ADDENDUM

Addendum No: 5

Project: UNC Charlotte East Village Infrastructure

Date: October 27, 2020

SHEET NUMBER
E-1

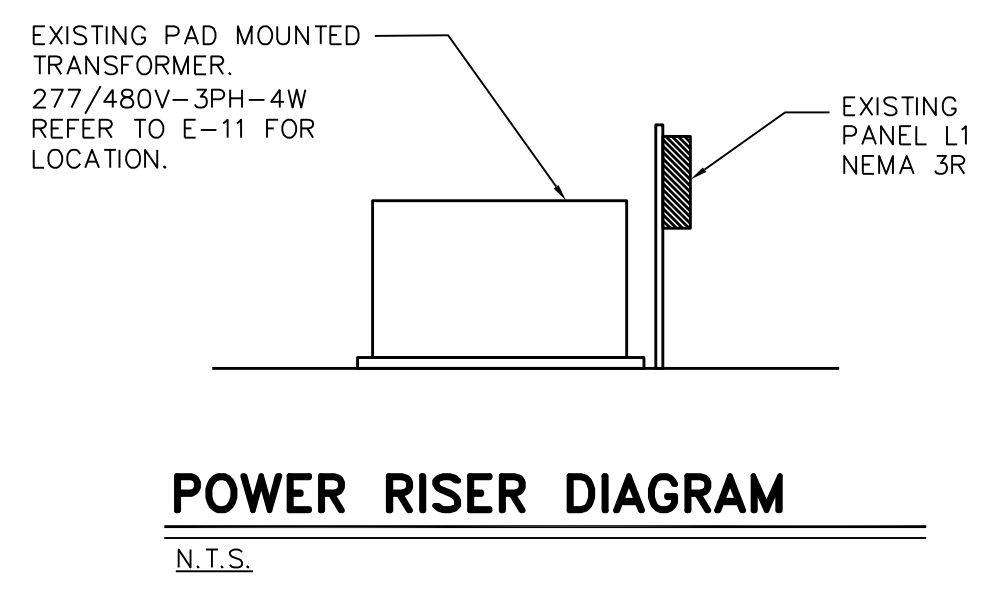
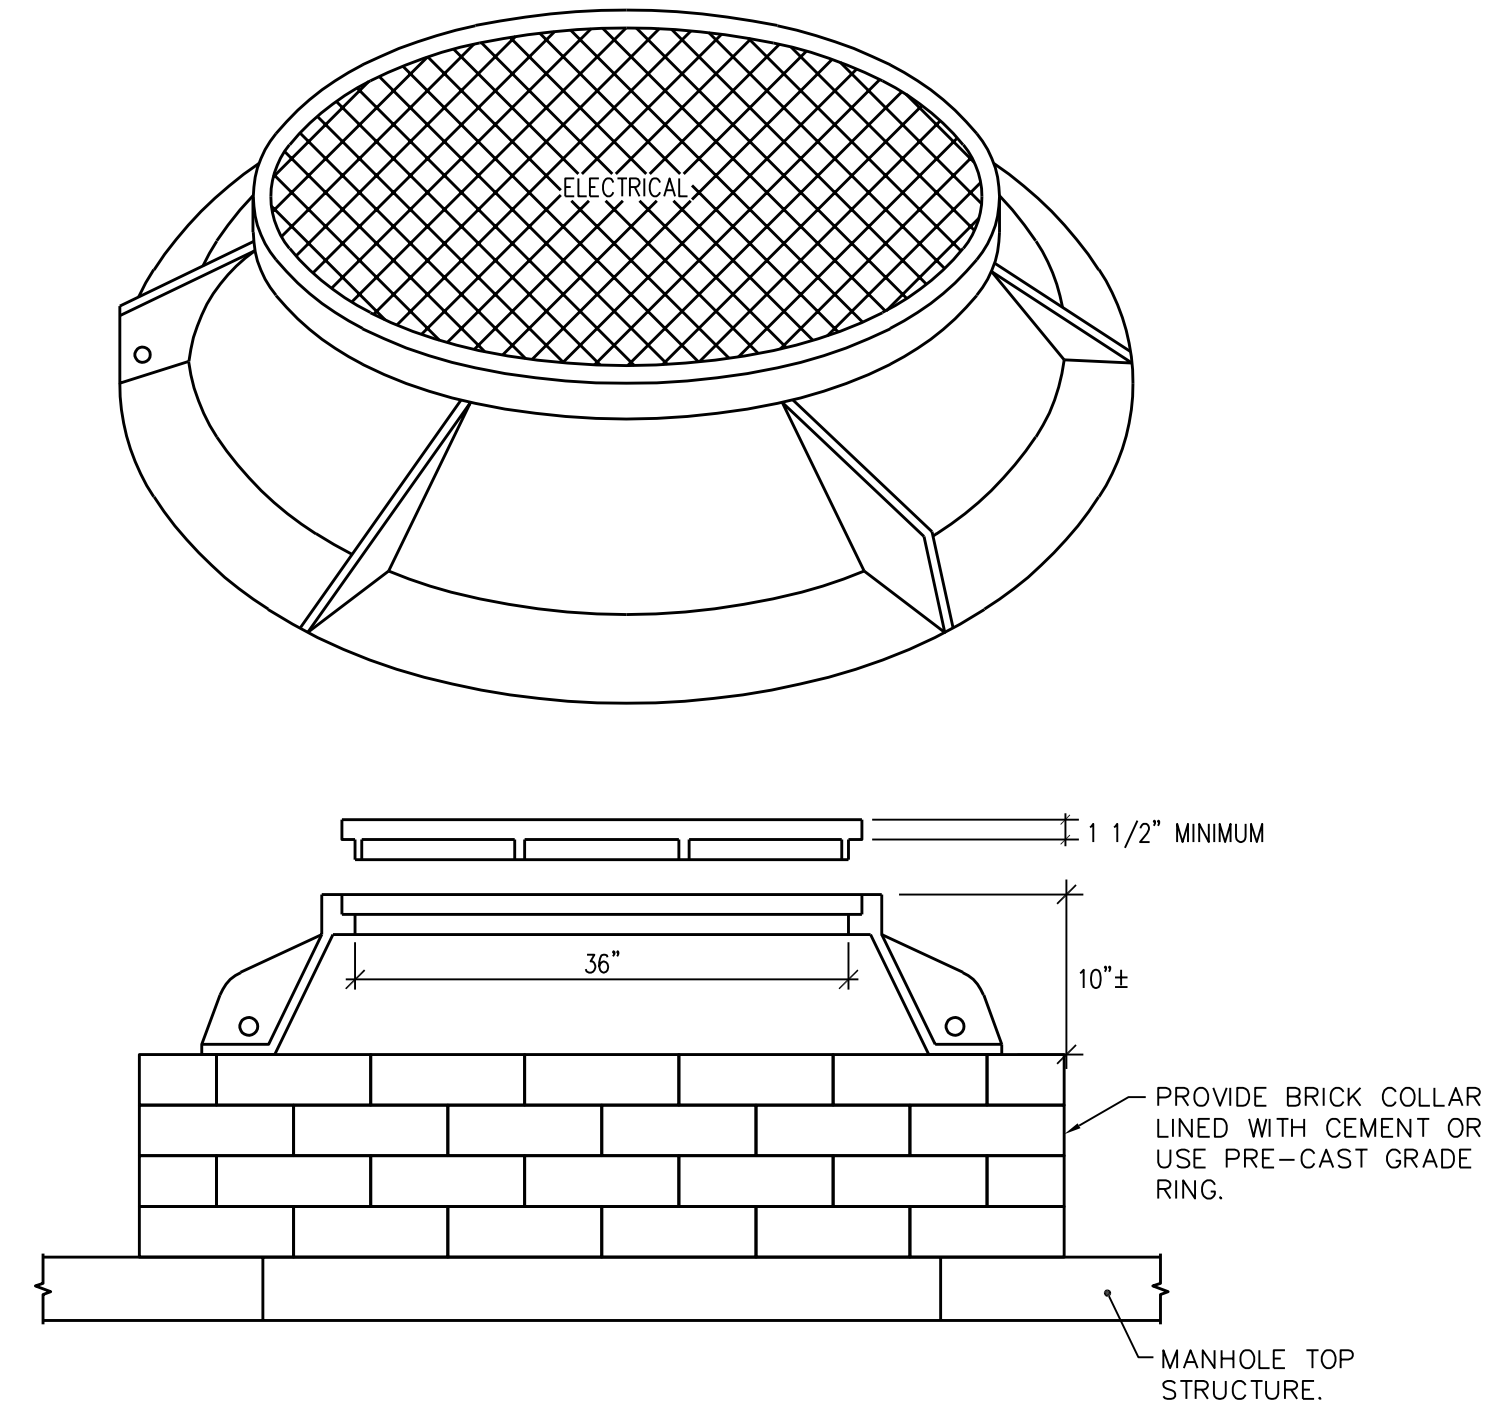
- b. All pedestrian light poles will be contractor provided. All non-pedestrian light poles will be provided by Owner, adequate supply is available in storage per University. Contractor to provide all light fixtures and add to poles provided by owner.

- LIGHT POLES FOR TYPES "SB" AND "SB2" TO BE PROVIDED BY OWNER. LUMINAIRES AND ANY ACCESSORIES REQUIRED FOR INSTALLATION OF THE COMPLETE UNIT SHALL BE PROVIDED BY CONTRACTOR. CONTRACTOR SHALL DRILL MOUNTING HOLES IF NECESSARY ON THE EXISTING POLES.

- ALL PEDESTRIAN POLES/FIXTURES TO BE PROVIDED BY CONTRACTOR.
